ADDENDUM NO.: 5

IFB or RFP NO.: Bid No. 645

Bid Title: Animal Cages and Cabinet Washer

Project: Queens College

Animal Facility RE-200 Suite

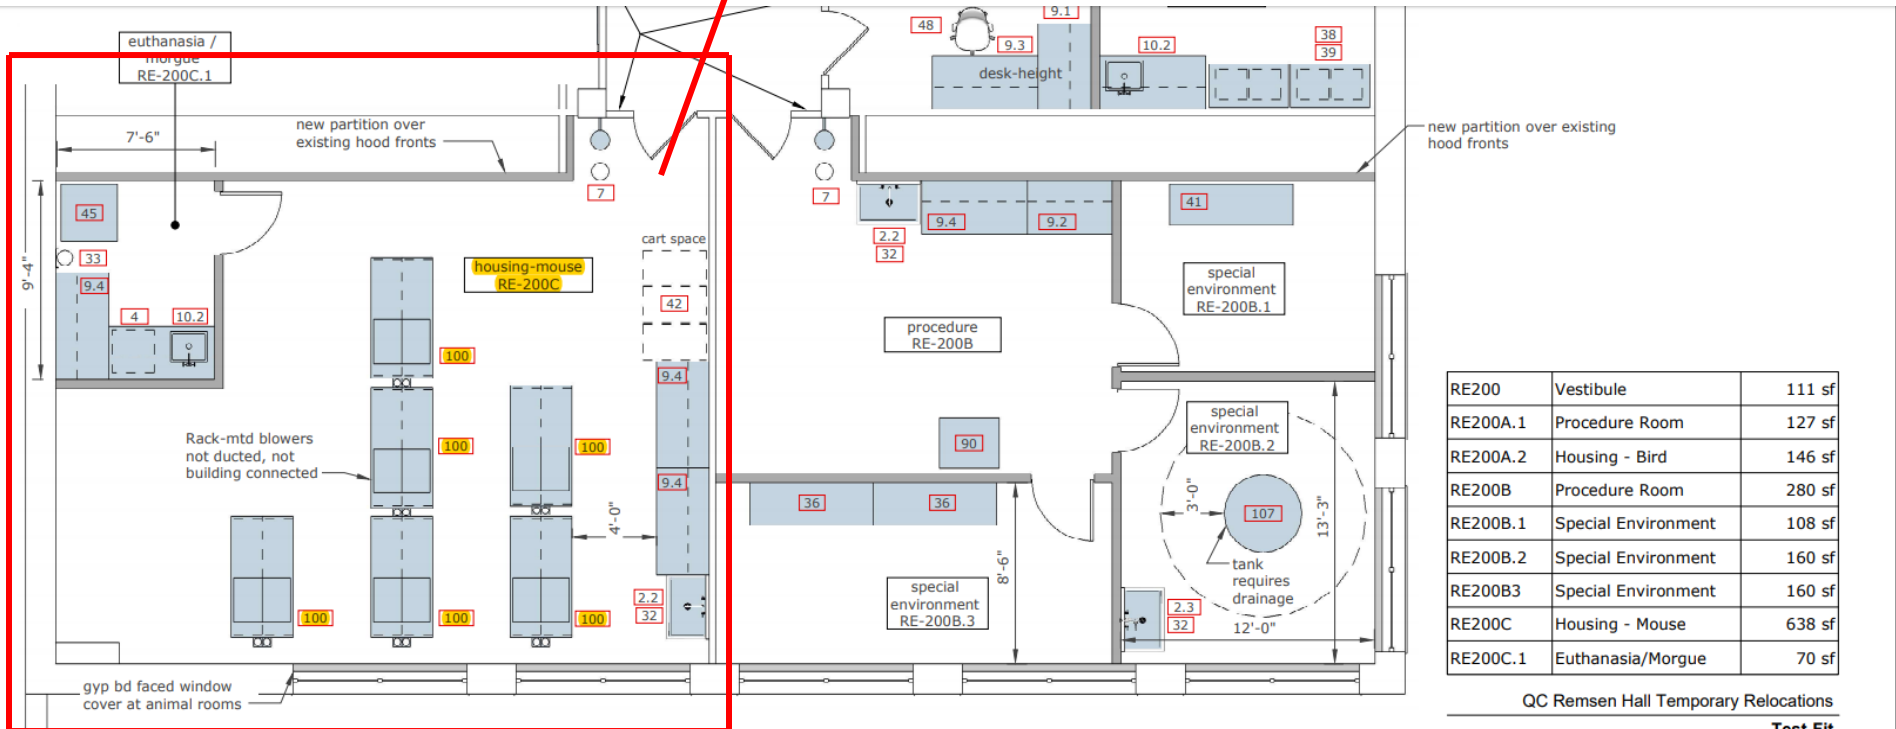
Question 3: We were just reviewing the most recent addendum and are still not clear how we are getting our racks through the door in question.

The redline [per the attachment] points to the door that is too narrow for our racks. Your response says there is a set of double doors we can use instead of this door but we do not see double door access to this room. Do you have additional details that we are missing?

Answer 3: Please see attached drawings. As indicated, there is a 36" and 12" side leaf that opens providing 48" opening into the room.
